# HydroQual, Inc.

June 13, 1994

Reviews of recently obtained Phase II-Round 1 Release Characterization data and results from sediment transport modeling of the Pawtuxet River have provided the basis for proposing three changes to the sediment sampling plan to support chemical fate modeling. The three changes are to 1) eliminate sediment sampling for silver, 2) limit the number of sediment samples that will be analyzed for chlorobenzene, toluene, and naphthalene, and 3) change the depth of sediment cores to 20 centimeters (from 40 centimeters). The rationale for these proposed changes is presented below.

FIGURE 1. PAWTUXET RIVER SURFACIAL SEDIMENT SILVER DATA

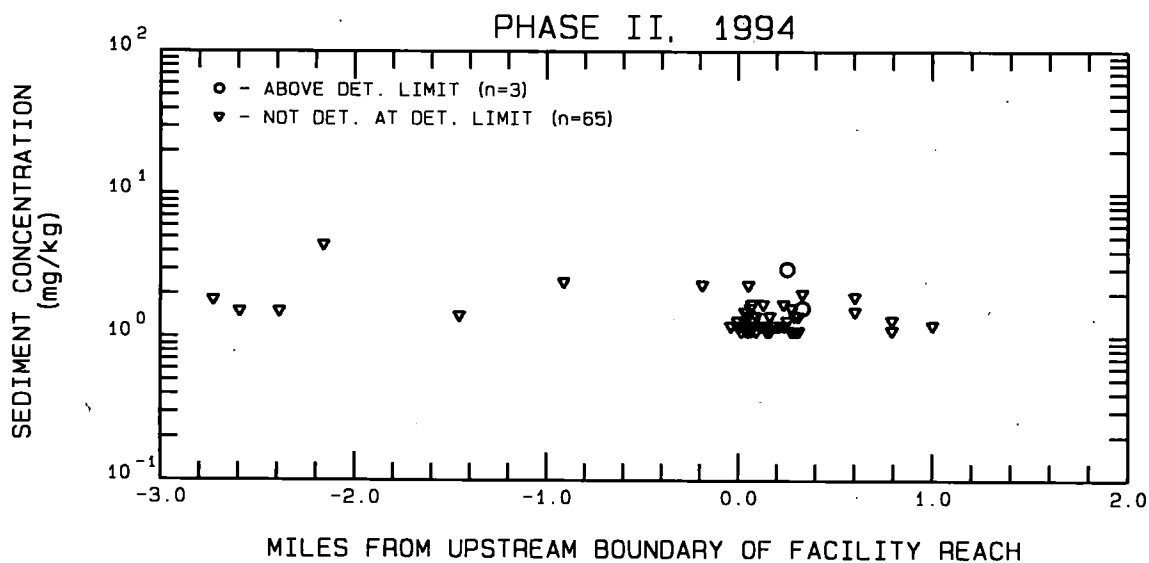
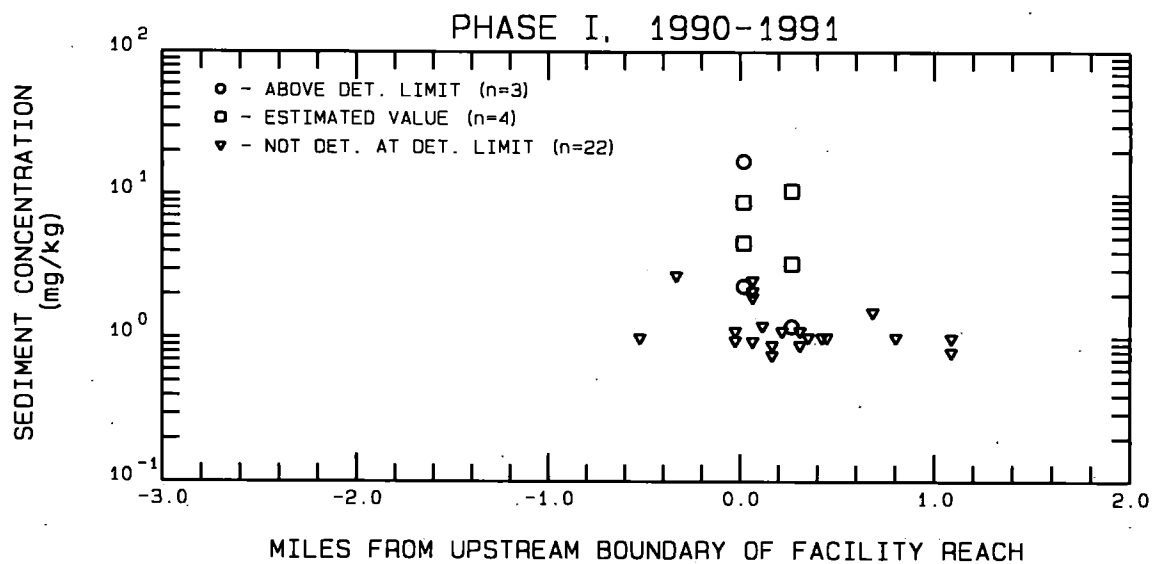
Phase II-Round 1 Release Characterization sediment silver data are shown on Figure 1, along with Phase I data. This recent sampling program resulted in only three detected concentrations of silver from 68 samples. Both Phase I and Phase II data indicate detected concentrations in only a limited portion of the river, with non-detected results from both upstream and downstream samples.

OK, BUT SHOULD WE BE LOOKING FOR ANOTHER  
METAL? (TO REPRESENT THE METAL FAMILY)  
FOR MODELING PURPOSES  
\* (-ZINC-) \*

FIGURE 2. PAWTUXET RIVER PHASE II, WATER COLUMN SILVER DATA, 1992

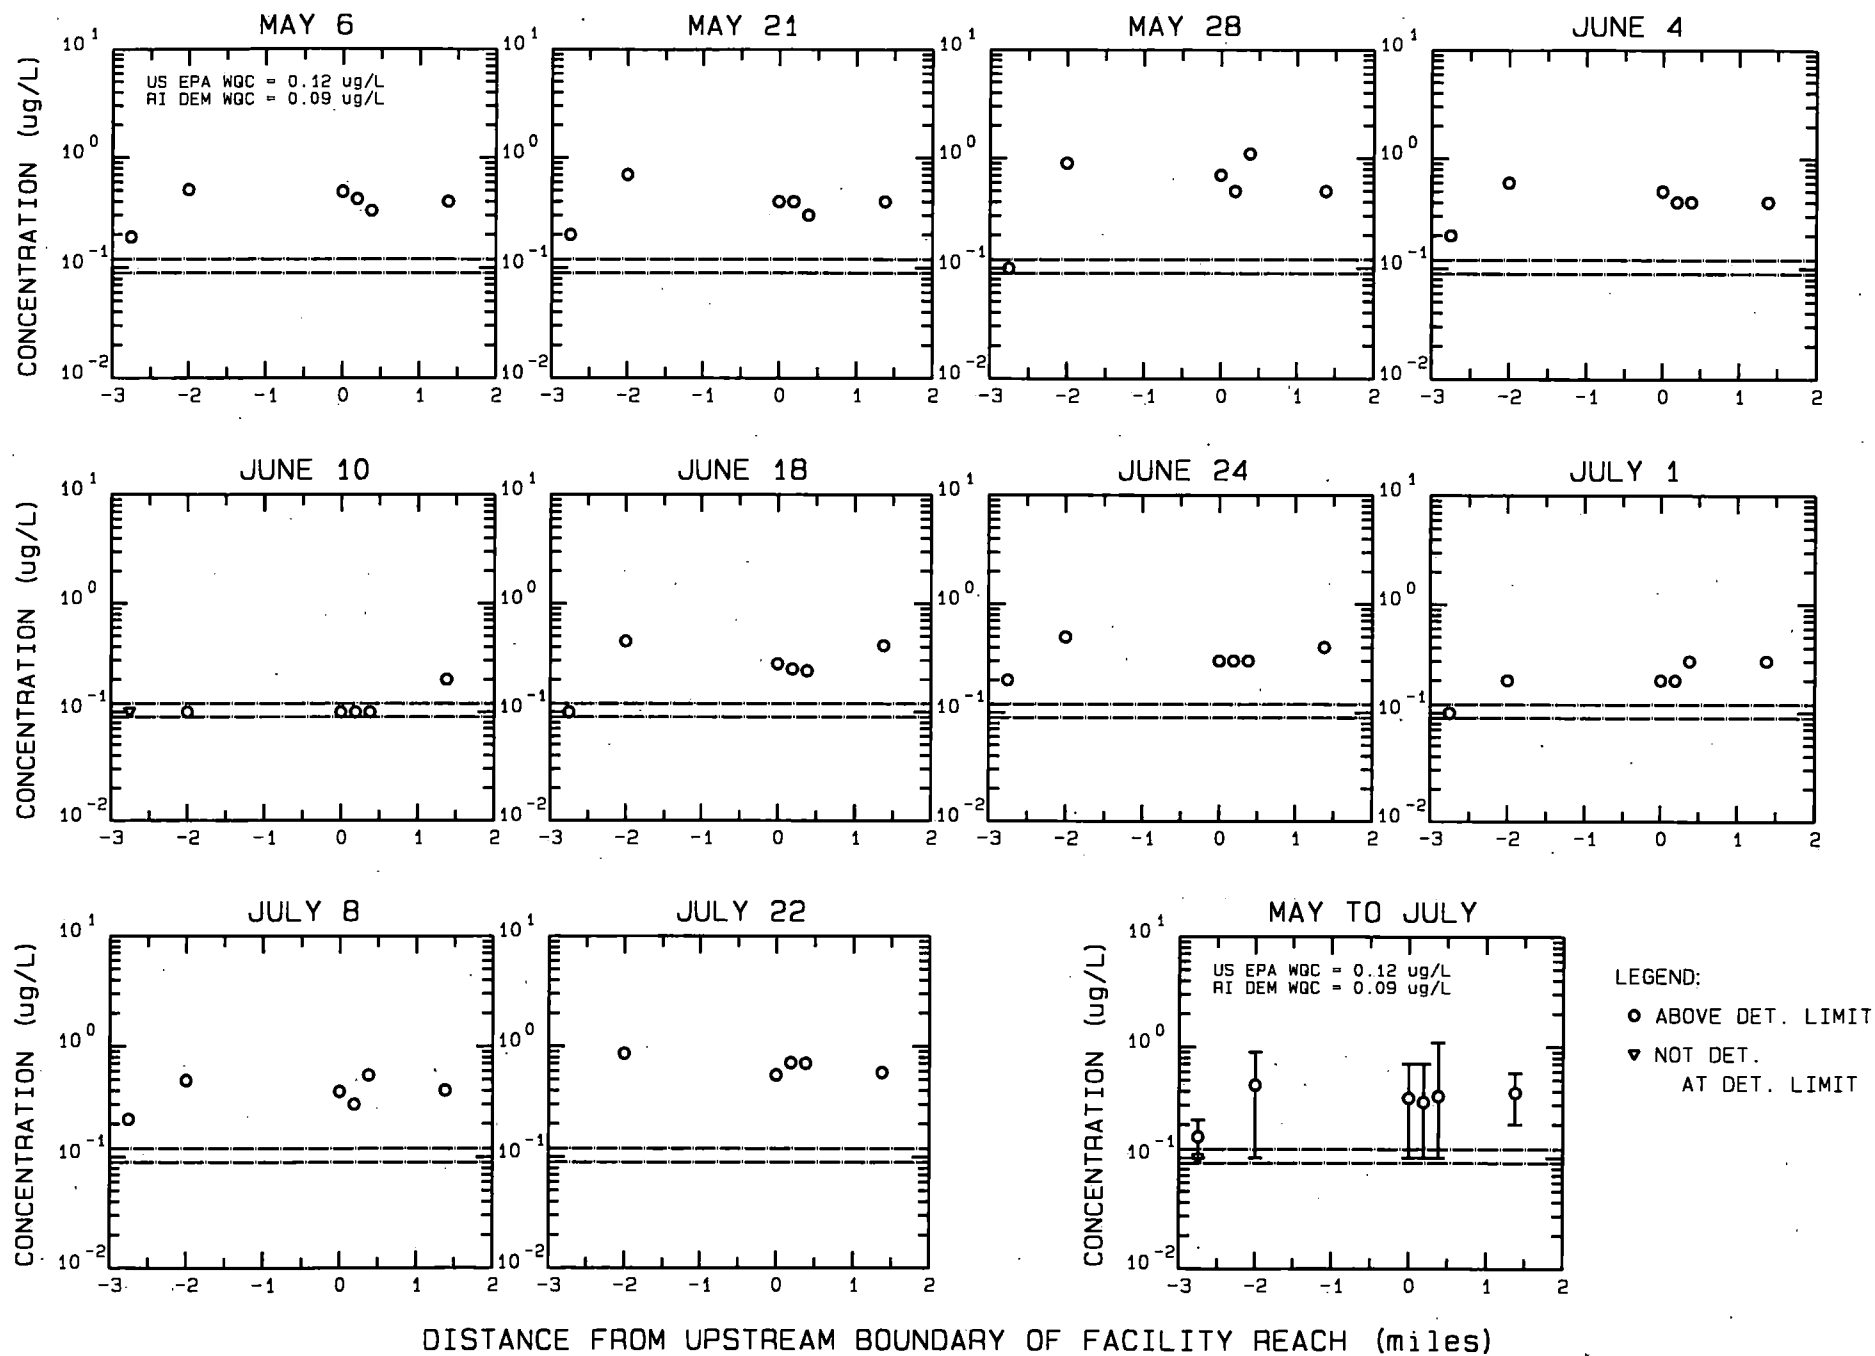
Silver was originally added to the list of chemicals to be sampled based on one water column concentration above both state and USEPA water quality criteria. Water column data collected between May and July 1992 (Figure 2) indicate that concentrations approximately 2 miles upstream of the Ciba Geigy facility are generally above water quality criteria. In addition, no spatial gradient through the Facility reach is observed. It is therefore recommended that analyses for silver in sediment samples should not be performed and that modeling the fate of silver should not be undertaken by Ciba Geigy.
